March 16, 2012

Re: **Response to IDEM's Request for Revised Remediation Work Plan
Approval Review and Technical Response to
General Notice of Potential Liability Review
Michigan Plaza**
3801-3823 West Michigan Street
Indianapolis, Indiana 46222
IDEM VRP #6061202
MUNDELL Project No. M01046

**FIGURE
2D**

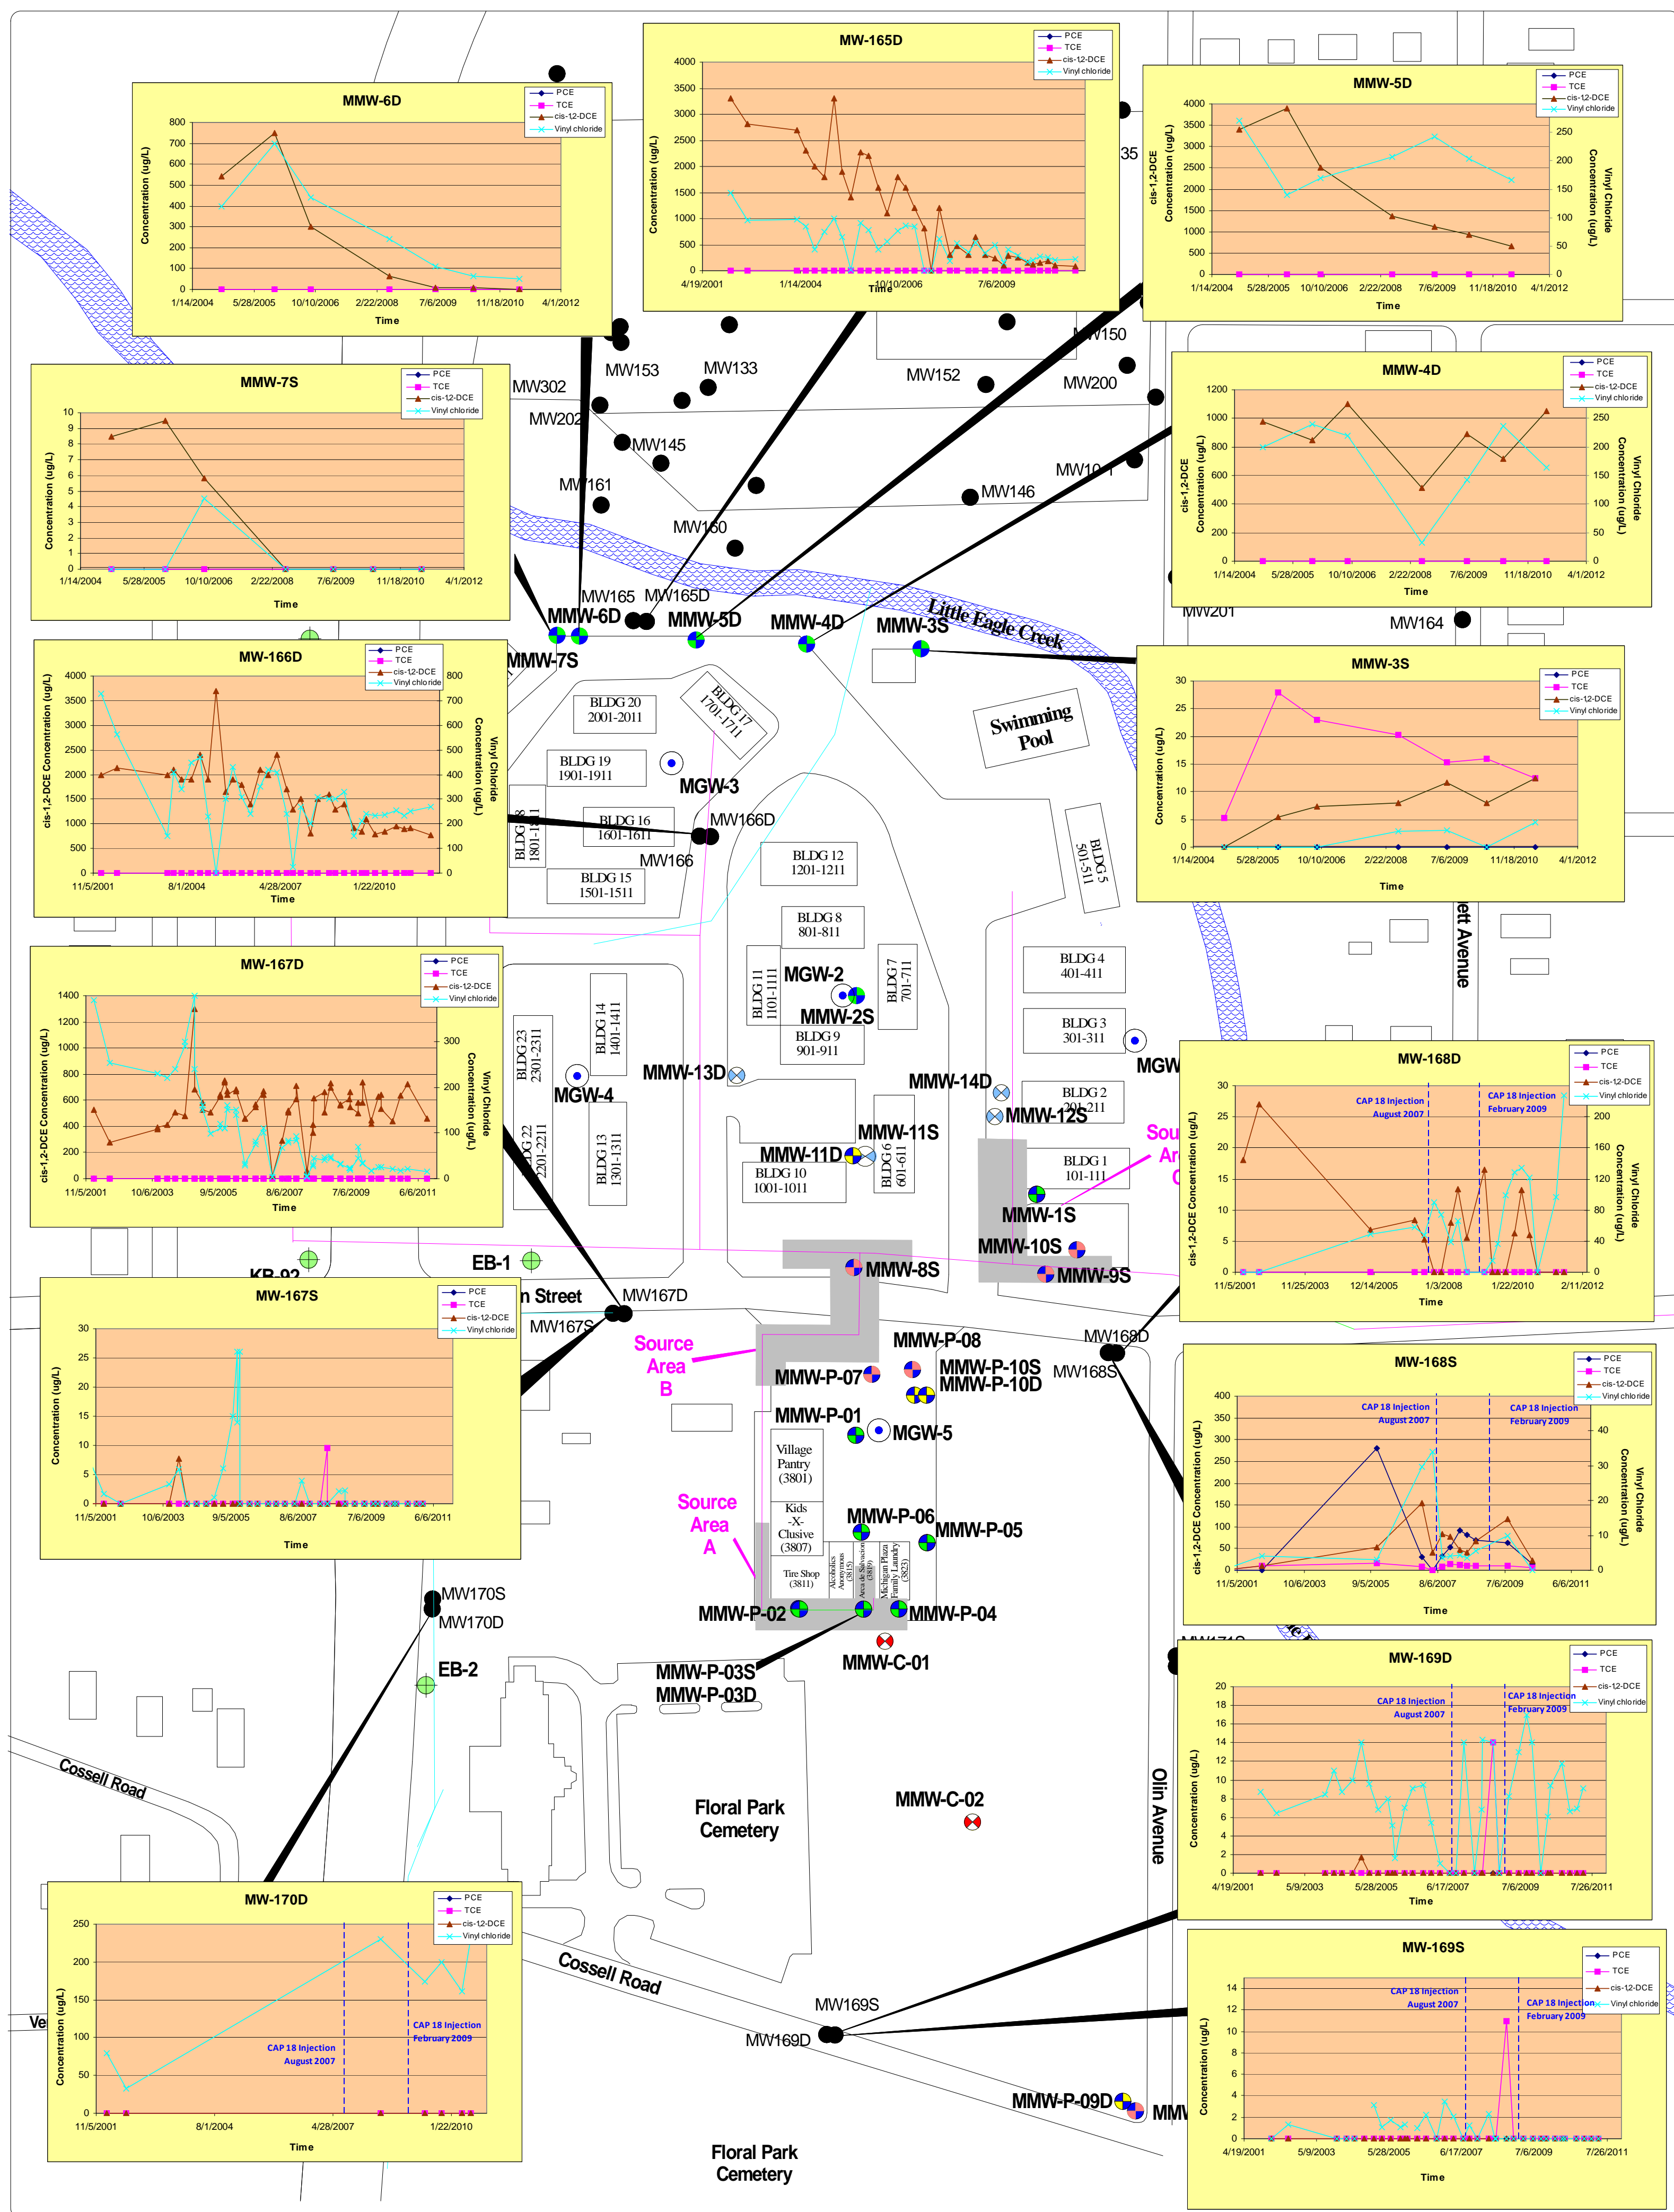
IDEM Comment No.6. *"In addition to complete delineation to the west of the Plaza, the plume is also not delineated south of MMW-P-09D, which contains vinyl chloride above RISC Industrial Default Closure levels. As requested in IDEM's November 17, 2008, comment letter additional delineation is necessary to determine the extent of VC."*

MUNDELL has completed downgradient delineation of the deep VC impacts in 2011 with a series of geoprobe borings as previously described (see **Figure 18** and *Additional Investigation Activities Summary Report*). Based on the results of this investigation, the VC extent in the deeper portion of the aquifer has been delineated. As noted above, MUNDELL proposes to augment the existing monitoring well network with the addition of two additional monitoring wells (south of the southwest corner of **Source Area A** and in the Floral Park Cemetery south of Cossell Road).

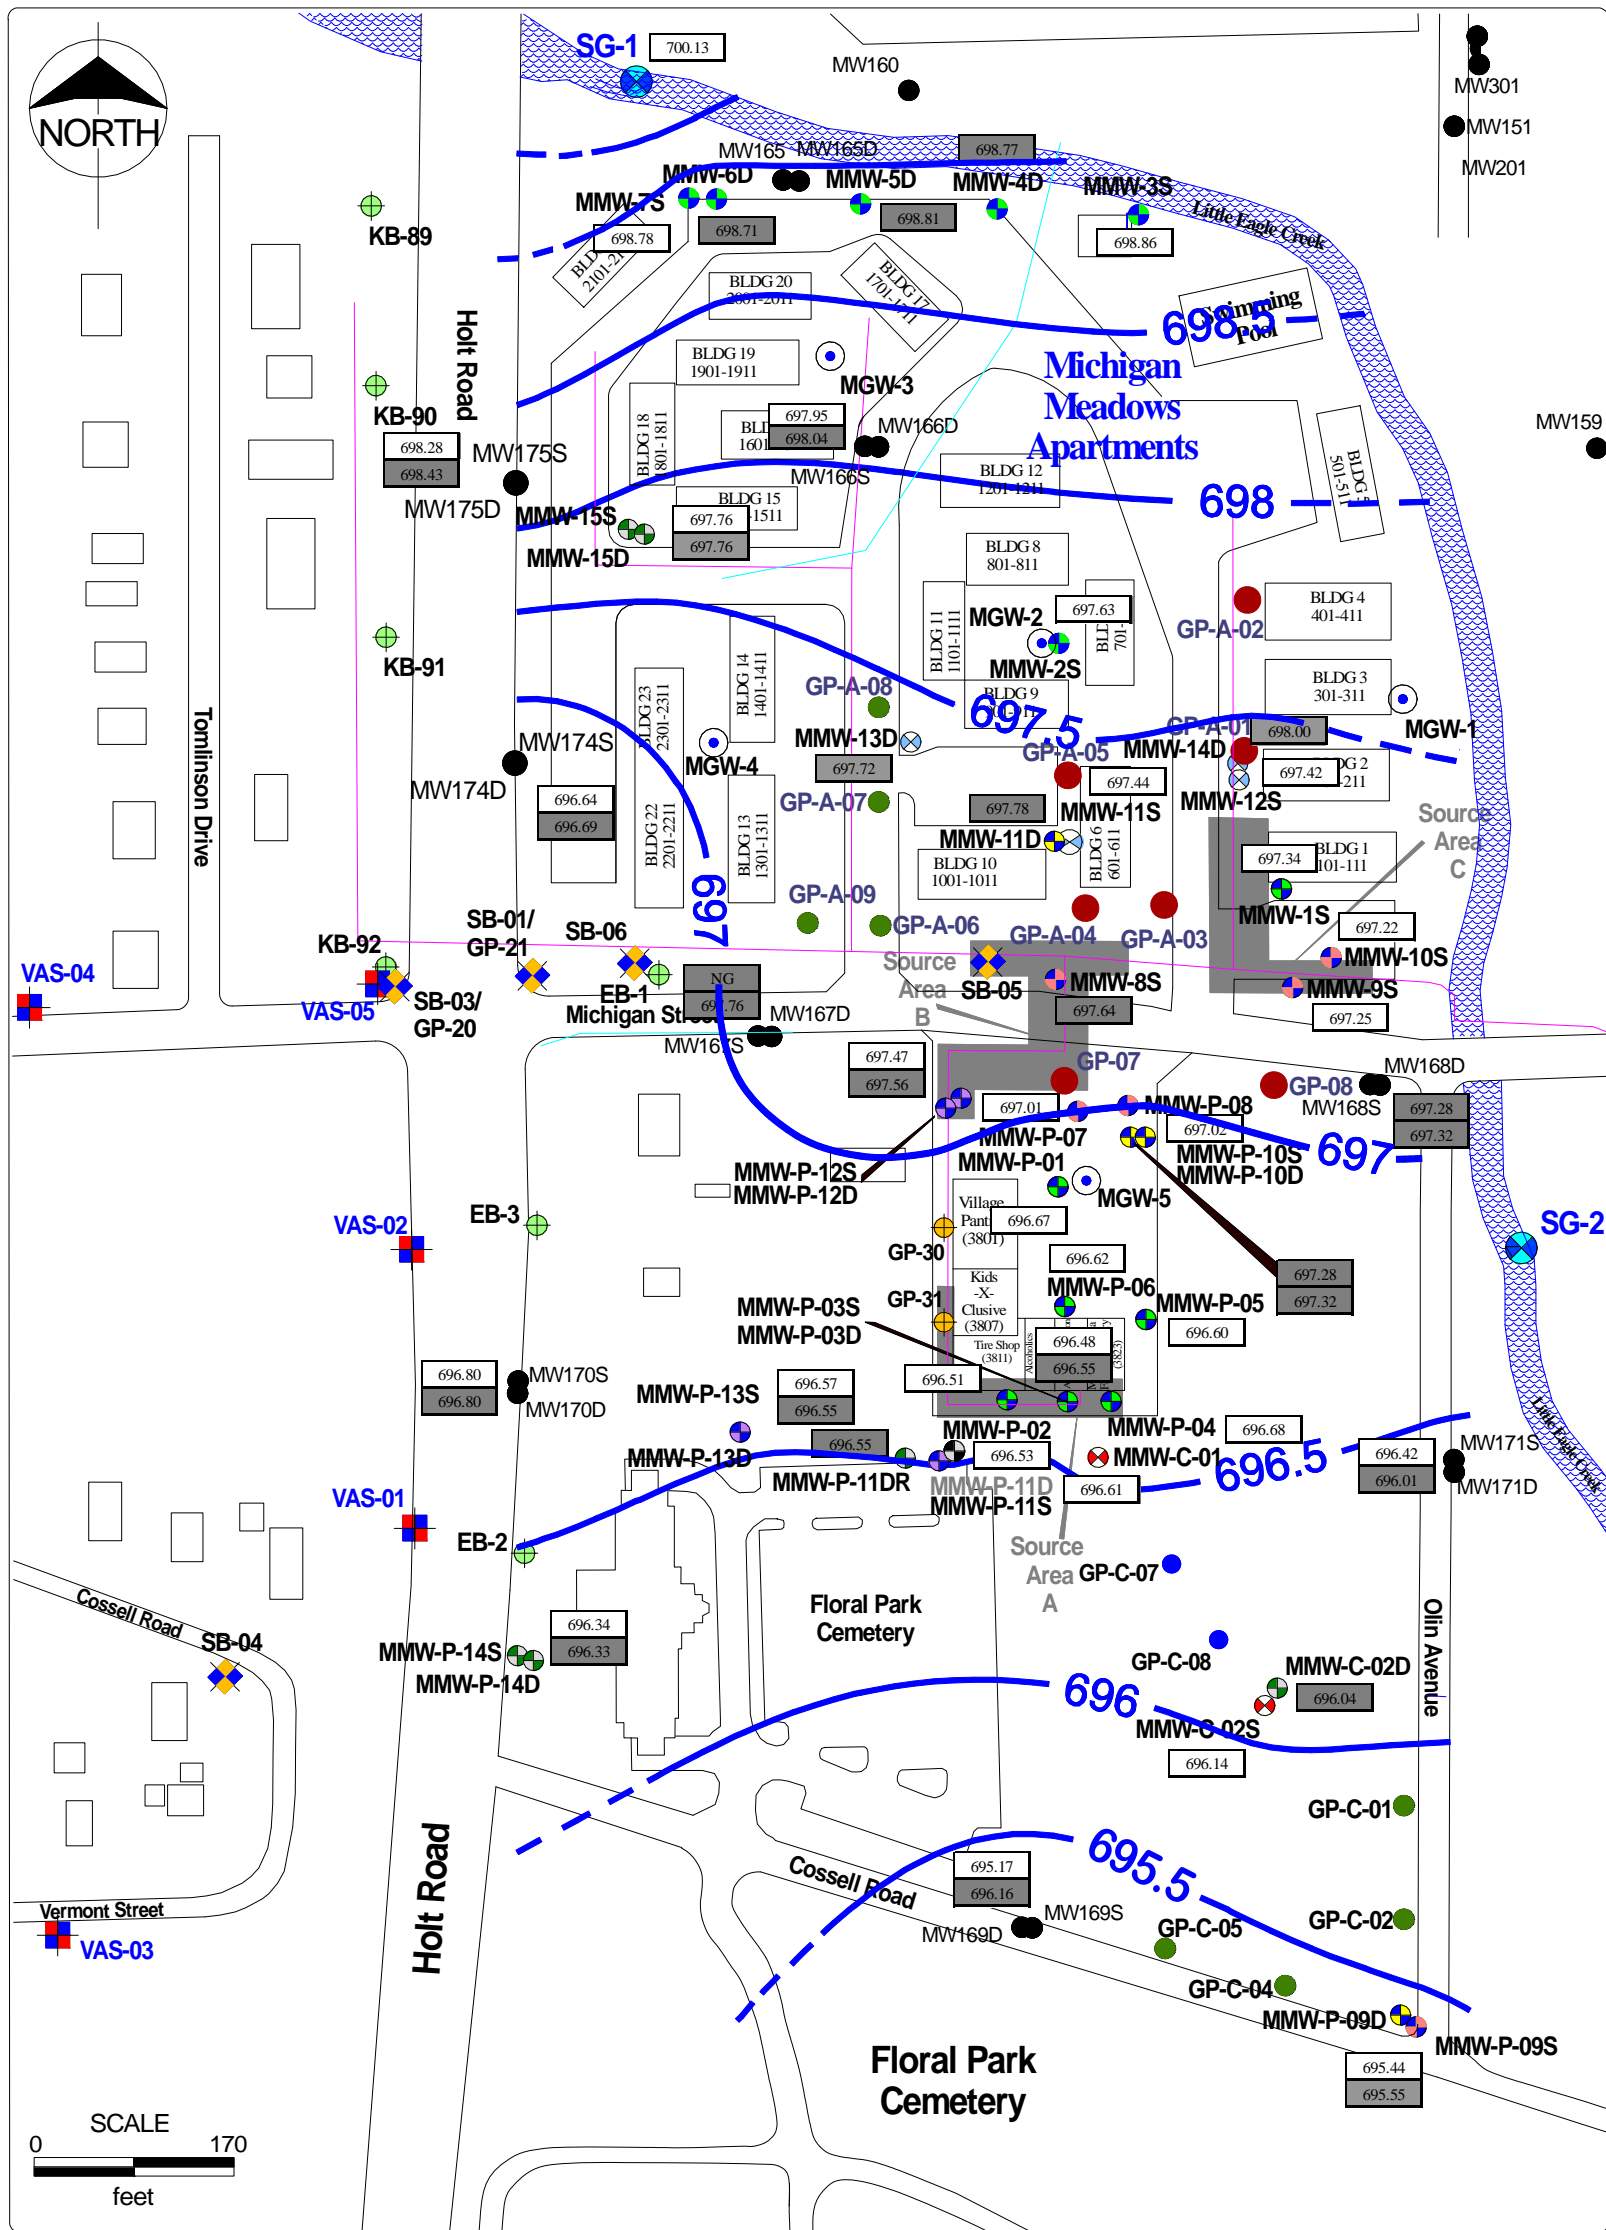
IDEM Comment No.1. *"Reviewing this report prompted IDEM to perform a confirmatory review of the soil and groundwater sampling completed prior to the CAP 18 injections in August 2007. From this review, IDEM cannot concur that the Michigan Plaza source areas and groundwater plume are fully defined. IDEM also cannot agree that the deep contamination across the site is wholly the responsibility of Genuine Parts or that Michigan Plaza cannot be the source of the vinyl chloride contamination in the residential drinking water wells. Additionally, a review of the 2005 sewer line investigation shows that the line along the immediate west side of the Michigan Plaza building was in poor condition, with worn joints and sags in the line. Since this part of the line was in similar condition to the lines in the known source area, is closer to the dry cleaner, and has not been investigated, it is inaccurate to definitively state that the source areas are fully delineated or that the vinyl chloride in the residential drinking water well cannot be from the Michigan Plaza source areas. Additional investigation to the west of the Plaza is required."*

During the 2011 groundwater sampling, no PCE was detected in the deeper portion of the aquifer along the western portions of the site (see **Figure 10**).
